14124
23 April 2014

**CARTER STREET URBAN ACTIVATION PRECINCT
12-14 BIRNIE AVENUE, LIDCOMBE**

Figure 4 – FSR Controls for Sydney Olympic Park for the Sports and Education Precinct
Source: Sydney Olympic Park Masterplan2030

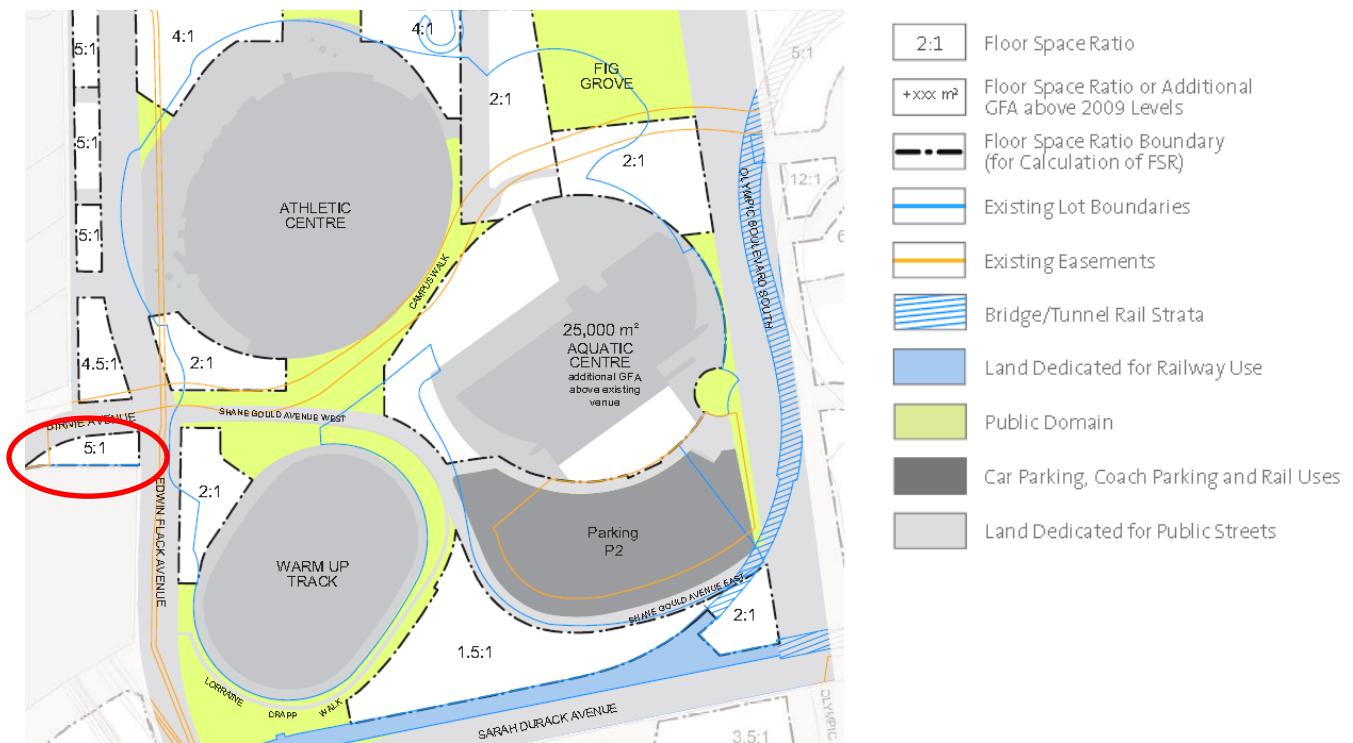
- To provide suitable building separation distances to the proposed Sydney Olympic Park development site at the corner of Birnie Avenue and Edwin Flack Avenue (See **Figure 4**). Due to the small area of the development site any development would be built to the boundaries with a nil setback as such separation distances will need to be provided wholly on the Swire Site; and
- To maintain a green space to Birnie Avenue.

Whilst the requirement for the 20m setback to the northern SOPA development site is understood, although considered inequitable, we can see no valid reason for the retention of a 20m setback along Birnie Avenue. We note that:

- The existing vegetation line along Birnie Avenue and Shane Gould Avenue West will be interrupted by the construction of a building with zero setbacks on the SOPA development site;
- The 20m setback is not required on the SOPA development Site and thus the resultant outcome would be an interrupted building line along Birnie Avenue;
- The setback is onerous given that there is no other local or arterial road within the Precinct that require such a large setback, all other roads are provided with a maximum 10m setback;
- Such a wide setback cannot be replicated on the other side of Birnie Road due to the existing location of the substation; and

It is therefore requested that the Department reduce the setback along the Birnie Avenue frontage to 10m consistent with all other road setbacks in the Precinct. A 20m setback to the SOPA development site would be retained as illustrated in the alternative scheme at **Attachment B**.
